UNITED STATES PATENT AND TRADEMARK OFFICE

APPLICATION NO.	FILING DATE	FIRST NAMED INVENTOR	ATTORNEY DOCKET NO.	CONFIRMATION NO.
09/899,334	07/05/2001	Johan Ubbby	1931/62303	2617

Office Action Summary

DETAILED ACTION

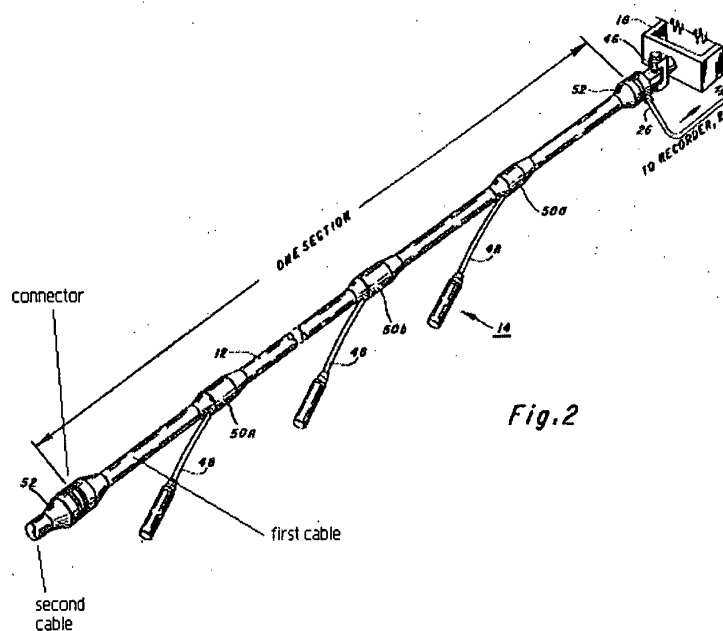
In response to applicant's arguments that Kruppenbach does not show "a monitoring cable for connection to a monitoring equipment and a plurality of respective cables, each of the plurality of respective cables including a plurality of individual wires each extending substantially an entire length of the respective cable, each of the plurality of individual wires of each of the plurality of cables having an end terminating at the connector", it is first noted that a recitation of the intended use of the claimed invention (e.g. for connection to a monitoring equipment) must result in a structural difference between the claimed invention and the prior art in order to patentably distinguish the claimed invention from the prior art. If the prior art structure is capable of performing the intended use, then it meets the claim. See *In re Casey*, 152 USPQ 235 (CCPA 1967) and *In re Otto*, 136 USPQ 458, 459 (CCPA 1963). Additionally, see the following figure.

In this case, the connector (52) is capable of being connected to a monitoring equipment, and each of the plurality of individual wires of each of the plurality of cables (first cable and second cable) have an end terminating at the connector (52).
